INDIANA DEPARTMENT OF TRANSPORTATION

STANDARDS COMMITTEE MEETING AGENDA

RE: Agenda for the February 16, 2006 Standards Committee Meeting

INDIANA DEPARTMENT OF TRANSPORTATION	
PUBLIC ROAD APPROACH TYPE C - GENERAL NOTES	
STANDARD DRAWING NO. E 610-PRAP-08	
REVISIONS	
NO. 9750	STATE OF INDIANA
DATE 03/01/08	PROF. ENGINEER
DESIGNED BY	CHECKED BY
DRAWN BY	IN CHARGE

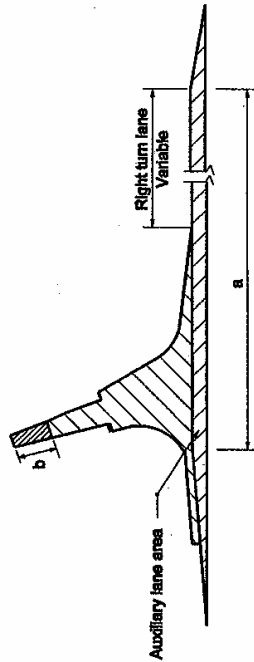
1. Embankment slopes built on either side of the approach within the mainline clear-zone shall be based on the functional classification of the public road as follows:

ROAD CLASSIFICATION	DESIGN SPEED mph	DESIGN YEAR ADT	SLOPE
All Freeways and other Multi-Lane Divided Highways	All	All	10:1
Other roadways	≥ 55	≥ 6000	10:1
	≥ 55	< 6000	8:1
	≥ 45 to < 55	All	6:1
	< 45	≥ 12000	8:1
	< 45	< 12000	4:1

2. Cross culverts under the public road approach which cannot be located outside the mainline clear zone will require appropriate end treatments at each end as shown on the plans.
3. If the approach is to be constructed of concrete, the details shall be as shown elsewhere in the plans for pavement thickness, joint type, and location.
4. The cross hatched  shoulder area indicates the limits where the shoulder is the same section as the approach pavement.
5. The pavement section for the auxiliary lane shall be as detailed elsewhere in the plans.
6. If the ADT for the public road is greater than 1000, the required pavement section shall be as shown elsewhere in the plans.
7. See Standard Drawing E 610 - PRAP - 07 for pay limit details.

Figure 05-25A

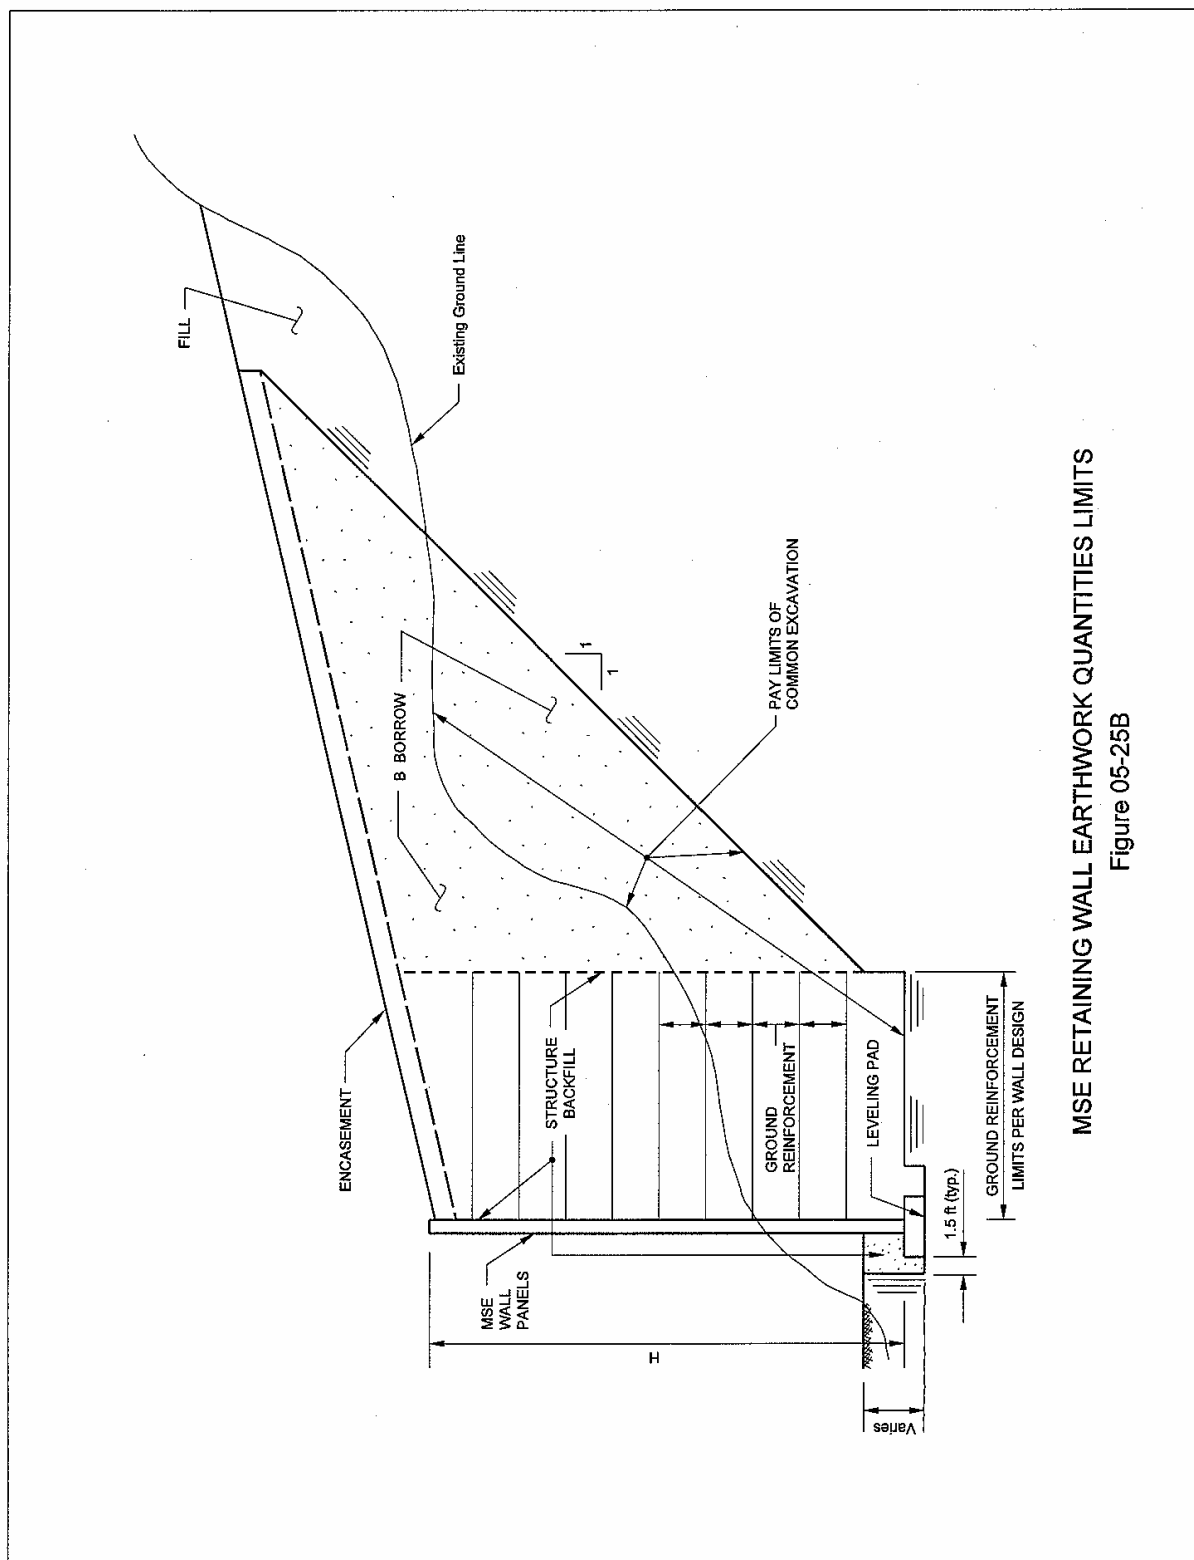
Figure 05-25A, Cast-in-Place Concrete Retaining Wall Earthwork
Quantities Limits.

These figures along with the corresponding metric versions are being revised to reflect
the limits of excavation.

MSE RETAINING WALL EARTHWORK QUANTITIES LIMITS
Figure 05-25B

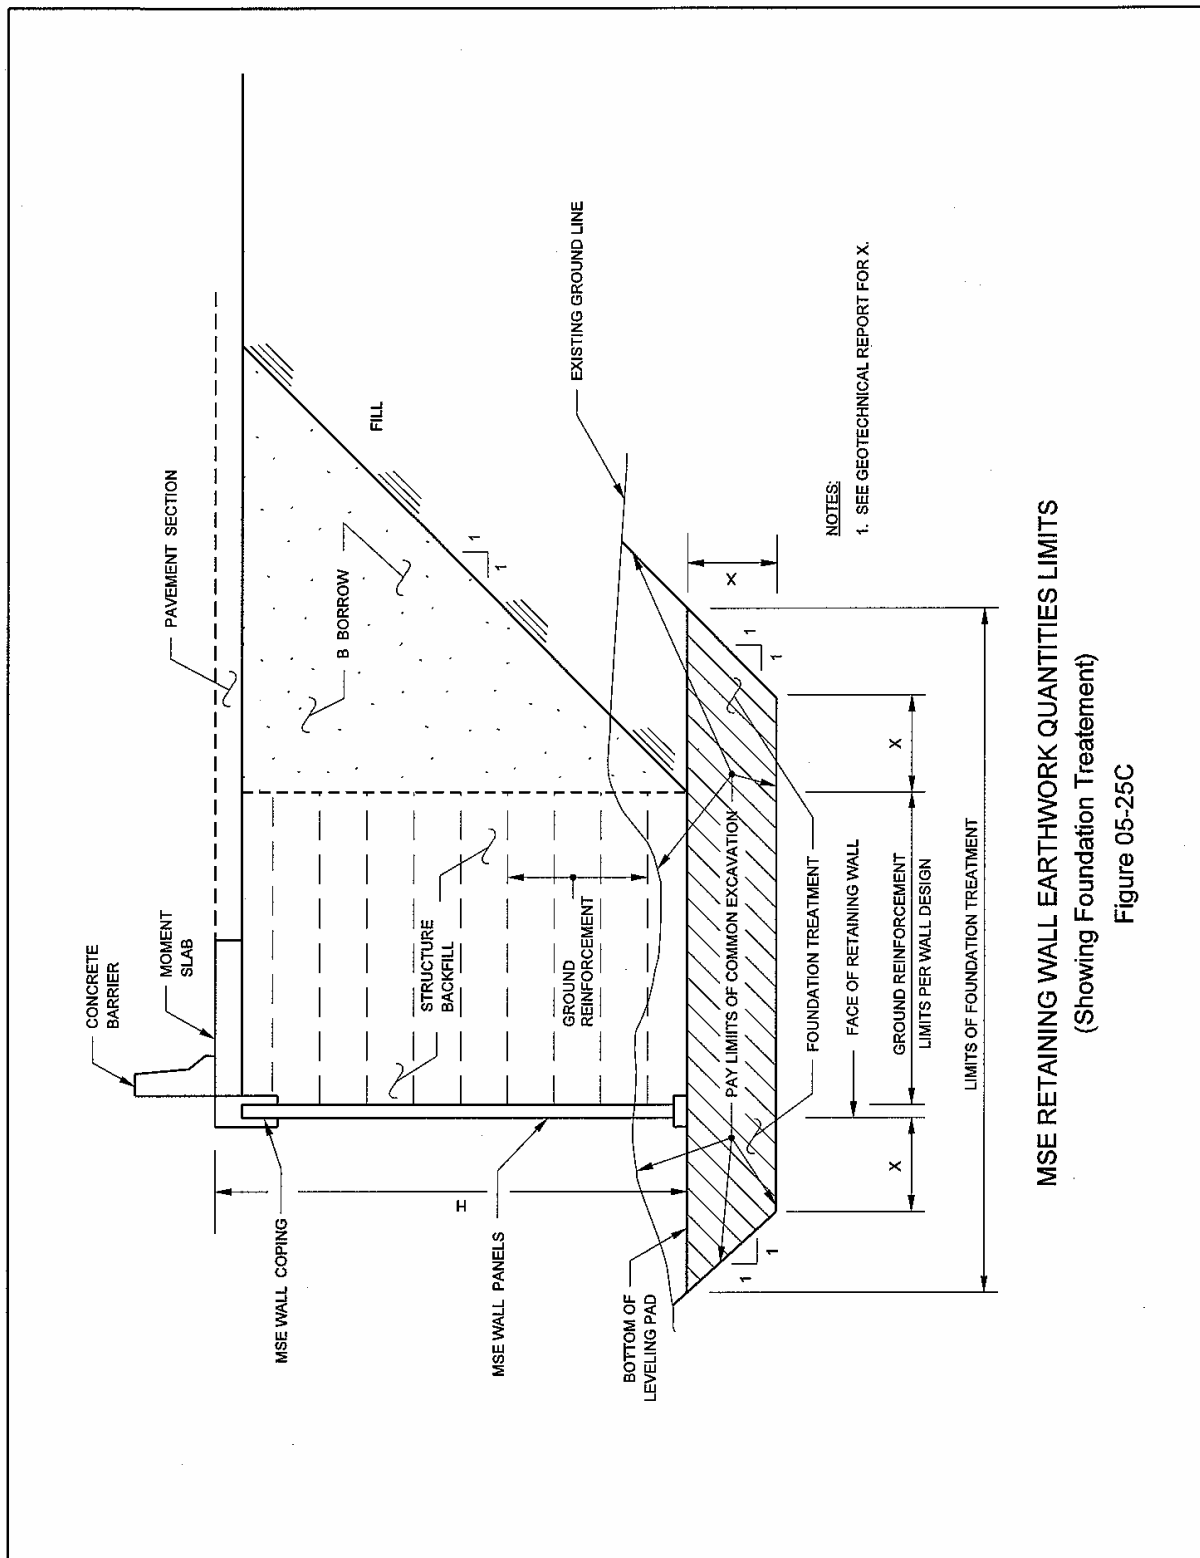
Figure 05-25B, MSE Retaining Wall Earthwork quantities Limits.

Figure 05-25C

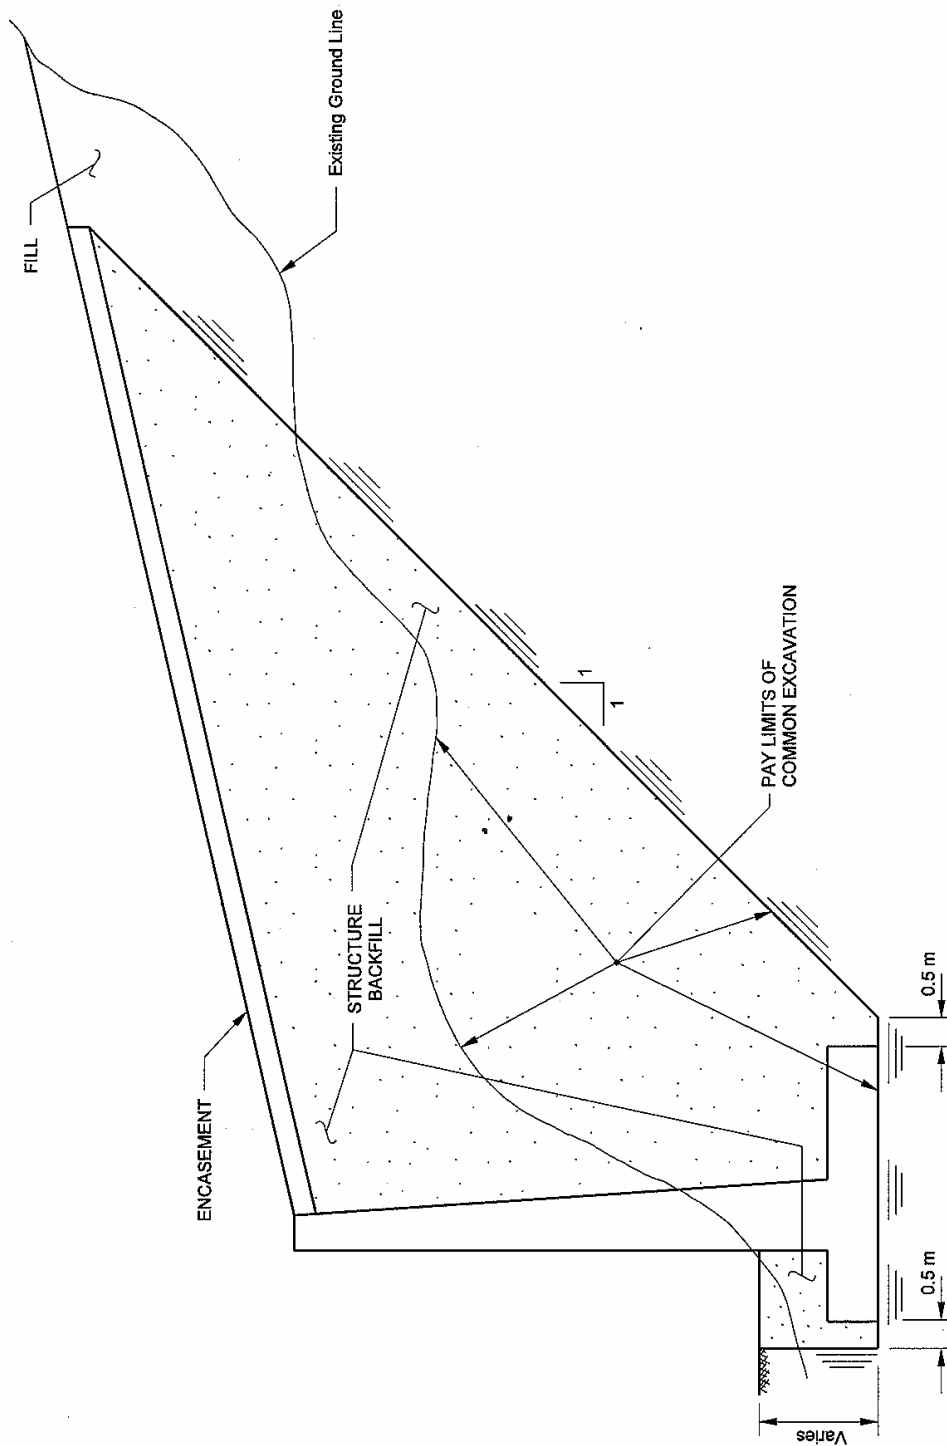
Figure 05-25C, MSE Retaining Wall Earthwork Quantities Limits.

Figure 17-4B

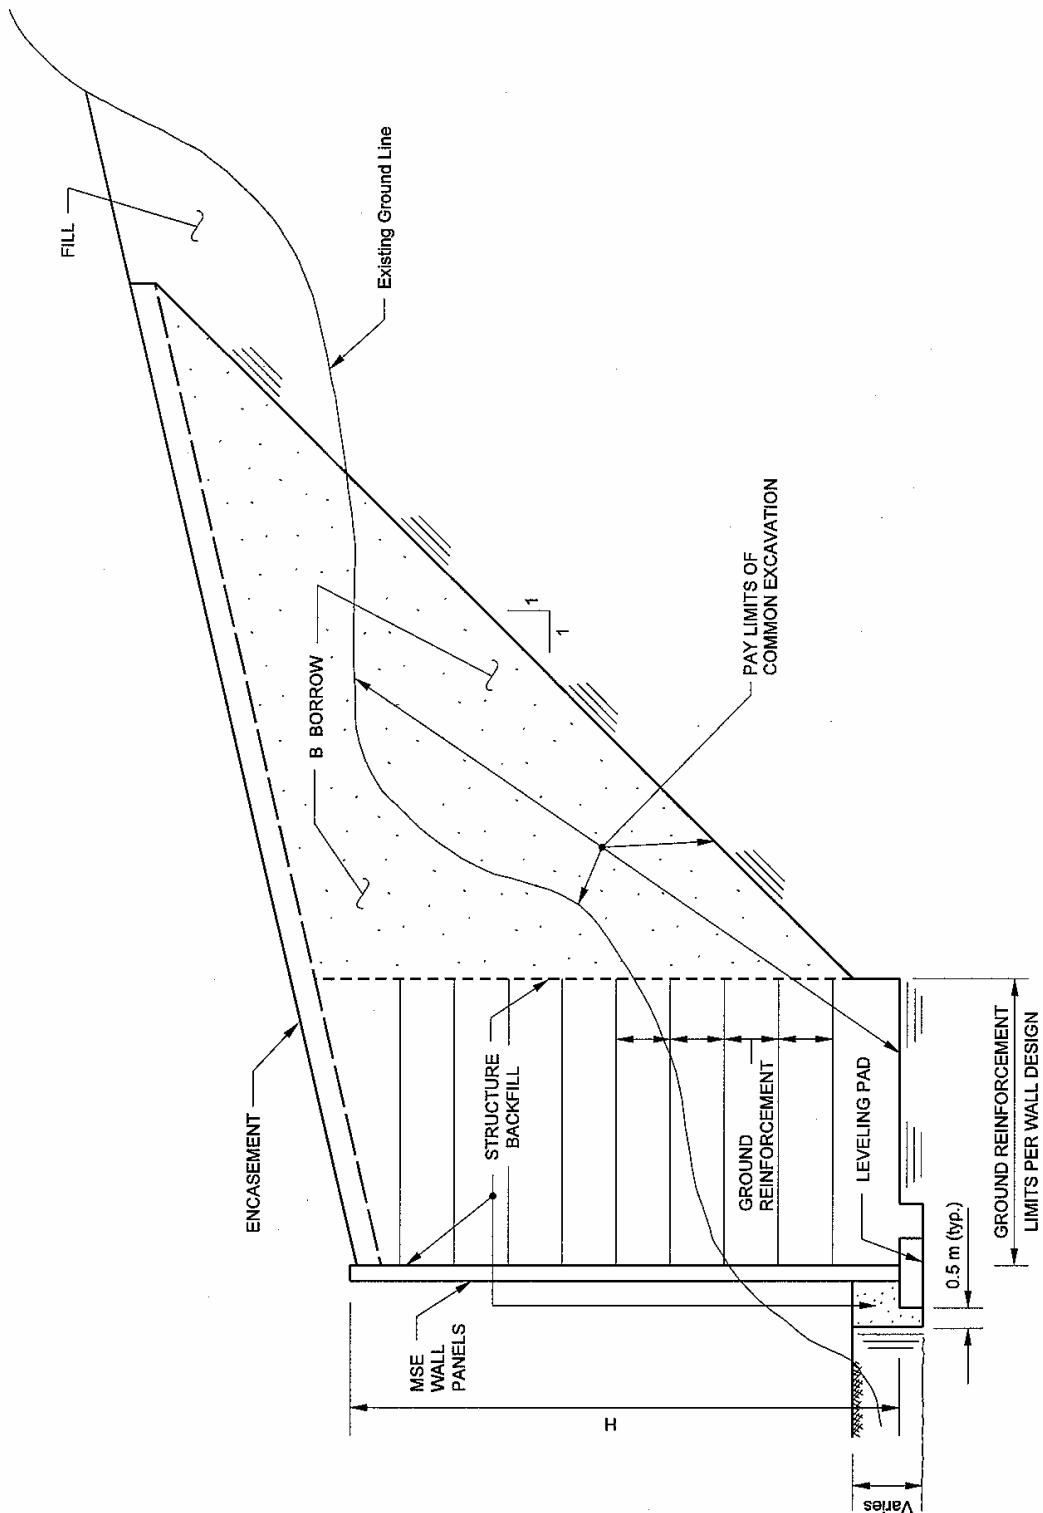
Figure 17-4B, Cast-in-Place Concrete Retaining Wall Earthwork Quantities Limits; Figure 17-4C, MSE Retaining Wall Earthwork Quantities Limits; and Figure 17-4D, MSE Retaining Wall Earthwork Quantities Limits Showing Foundation Treatment, each illustrate the typical pay limits for excavation and backfill material quantities for retaining walls. The contractor may select an alternate wall design. However, the earthwork quantities should be calculated based on the outermost neat-line construction limits for the wall type shown on the plans.
